## Former Superior Manufactured Gas Plant Site

Upland DRAFT RAOR Update  
December 7, 2020

# Benzene in GW

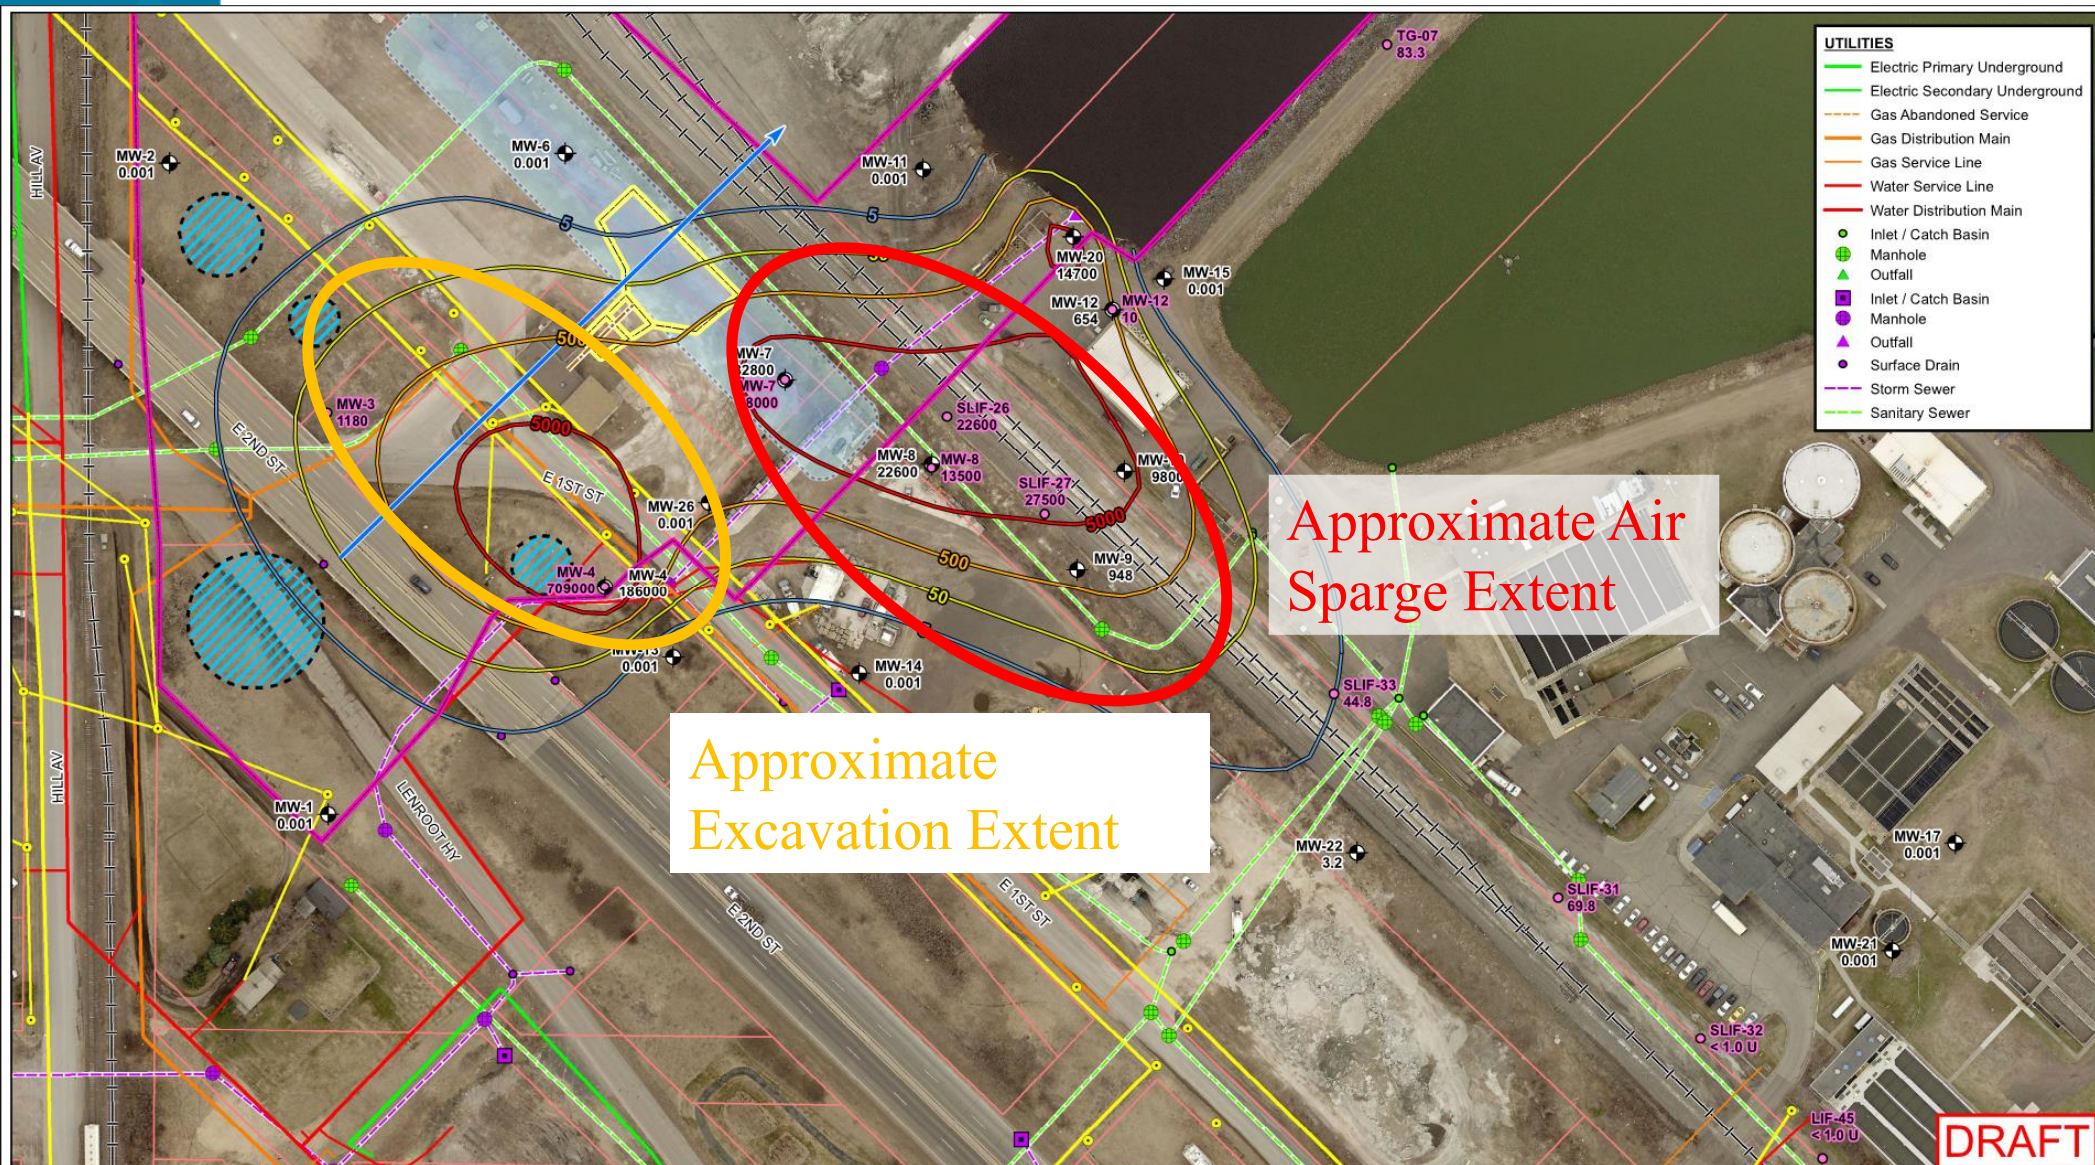
- ◆ **Comment 3:** *The draft RAOR does not evaluate remedial action options for contamination beneath the City of Superior Wastewater Treatment Plant (WWTP) or the BNSF railroad tracks downgradient of the area where active remedial action is proposed in the RAOR. Remedial action options are necessary for all areas of contamination at the site.*

- ◆ **Comment 3 Response:**
  - ▶ The WWTP area has isolated soil-GW impact of *de minimis* mass, which is off site and from construction fill activities.
  - ▶ AS/Bio provides better access than excavation beneath BNSF tracks.
  - ▶ Groundwater plume reduction will occur downgradient (e.g. SLIF-31, MW-20) with source removal. Attainment of GW RAO is considered in the Remedial Options.
